## Planning Commission Staff Report

May 21, 2008  
Item 4.a.

- SUBJECT:** PREV-695
- APPLICANT/  
PROPERTY OWNER:** Dave DiDonato/Donato Builders, Inc.
- PURPOSE:** Work session to review and receive comment for a proposal for a PUD rezoning and development plan to construct fourteen (14) two-story single family detached homes on an approximately 1.2-acre site.
- GENERAL PLAN:** Medium Density Residential – two-to-eight dwelling units per gross acre
- SPECIFIC PLAN:** Downtown Specific Plan
- ZONING:** Rezone from the existing R-1-6,500 zoning district to the PUD-HDR (Planned Unit Development – High Density Residential) District
- LOCATION:** 4189 Stanley Boulevard
- ATTACHMENTS:**
1. Exhibit B, Discussion Points
  2. Exhibit A, Conceptual Site Plan, Floor Plan, Elevations, dated “Received May 7, 2008”
  3. Exhibit C, Location Map

**Proposed Site Plan**

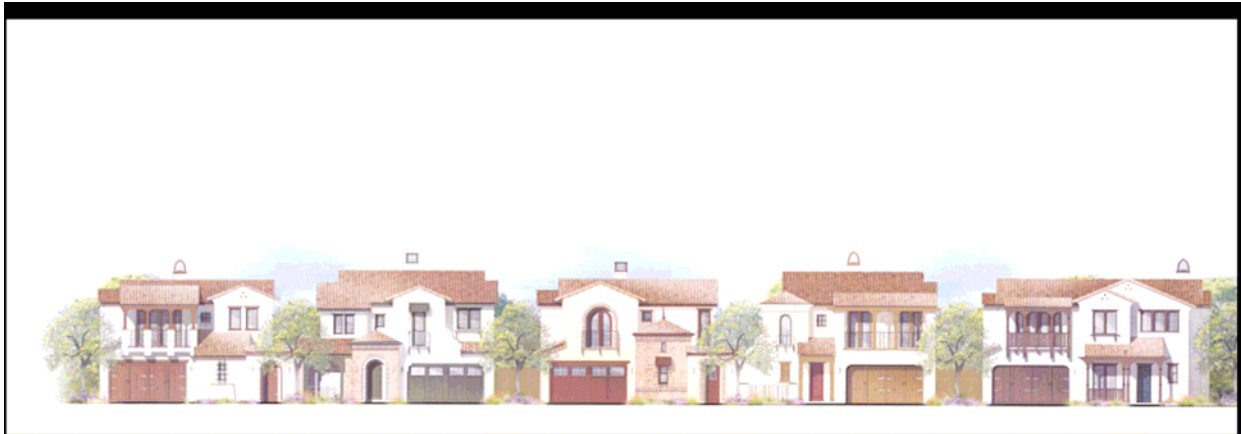
Discussion Point No. 2 – Would the proposed site plan be acceptable?

The proposed plan shows that the lot size varies from 2,390 square feet to 3,420 square feet. A 20-foot wide private road would provide primary access to the development. This driveway would then branch off and become a driveway to each home. Landscaping pockets are proposed in front of each home; however, there is no sidewalk within the development. The number of driveways conveying on the end of the private road exceeds the number of driveways that would convey on a typical cul-de-sac. Would the proposed layout be acceptable?

Discussion Point No. 3 – Would the guest parking area be acceptable?

As shown on the proposal, there are no guest parking spaces proposed within the development. The applicant proposes to use driveway area as the designated guest parking for each home. In a straight single-family zoning district, the front yard setback is 23 feet. Staff has found that a 20-foot deep driveway may also accommodate vehicles

parked on the driveway without encroaching into the sidewalk area. In this proposal, not all of driveways have the depth of 20 feet. Staff has been requesting in other high-density development that guest parking spaces other than the driveway area be provided. Would this guest-parking proposal be acceptable?

Discussion Point No. 4 – Would the proposed setbacks be acceptable?

As shown on the site plan, the proposed side yard setbacks are five feet on each side except that for Lots 5 –9, one side yard setback is greater than five feet. The site plan shows that all lots have a rear yard setback of three feet. The site plan does not specify the front yard for each home. Would the proposed side and rear yard setbacks be acceptable?

Discussion Point No. 5 – Would the proposed open space area for the development and for each home be acceptable?

Based on the site layout, it appears that a small courtyard averaging approximately 225 square feet would be provided for each home. The proposed development does not include a common open space area. Given its proximity to Downtown, would it be accept not to have individual open space for all of the lots and not to have a common area within the development?
